**2<sup>nd</sup> Further Information**

**Proposed Temporary Open Storage of Construction Material and Machinery with  
Ancillary Facilities for a Period of 3 Years and Associated Filling of Land  
in “Agriculture” Zone, Various Lots in D.D. 82, Ta Kwu Ling, New Territories**

**(S.16 Planning Application No. A/NE-TKL/761)**

Responses-to-Comments

ANNEX II

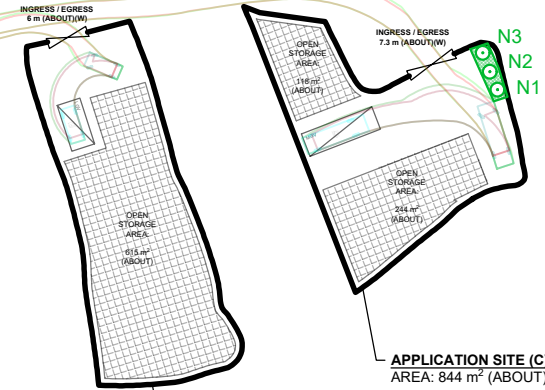
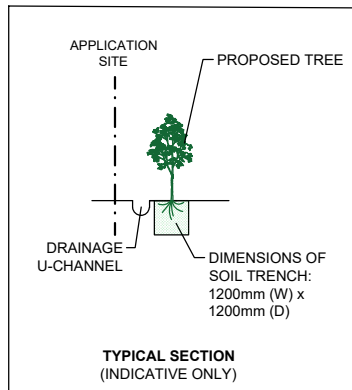
(a)	Having reviewed the revised landscape proposal (Annex II), larger tree pits (i.e. 1.2m (W) x 1.2m (L) x 1.2m(D)) are provided for the 4 nos. of proposed new trees and continuous soil trench are provided for new trees N2 and N3. However, tree information and proposed tree treatment on existing trees are not provided. Potential impact on the landscape resources cannot be reasonably ascertained.	According to the tree survey conducted on 11.9.2024 and 25.9.2024, a total of <u>21</u> nos. of trees were identified within the Site ( <b>Annex I</b> ). No Old and Valuable Trees (OVTs) or protected species has been identified in accordance with the Development Bureau (DevB) TCW No. 5/2020 – Registration and Preservation of OVTs and the Forests and Countryside Ordinance respectively. Due to the proposed hard-paving works for site formation of structures and circulation purposes, all existing trees will be affected, and it is not proposed to retain any of the existing trees within the Site.

(b)	Our previous comment in RtC item 4(b) remains valid. The applicant is advised to provide basic information (e.g. numbers, species, size, general conditions and tree photos) on existing trees within and along the site boundary, and proposed tree treatments for TPB’s consideration.	Among the 21 nos. of identified trees, 18 <i>Leucaena leucocephala</i> are recorded. According to Legislative Council’s 2020 discussion on managing invasive alien species <sup>1</sup> , Agriculture, Fisheries and Conservation Department (AFCD) has recognized <i>Leucaena leucocephala</i> as one of the major invasive alien species in Hong Kong. The proposed tree felling is therefore deemed necessary.  A revised landscape proposal is submitted by the applicant to provide landscape mitigation measures for the proposed development ( <b>Annex II</b> ). <u>3</u> new trees (N1 to N3), with

<p>continuous soil trench, are proposed to be planted along the east periphery boundary of the Site to compensate for the loss of trees. All these new trees within the Site will be maintained by the applicant during the planning approval period.</p>
(c)	<p>Approval of the application does not imply approval of tree works such as pruning, transplanting and felling. The applicant is reminded to seek approval for any proposed tree works from relevant authority prior to commencement of the works.</p>	<p>Noted.</p>
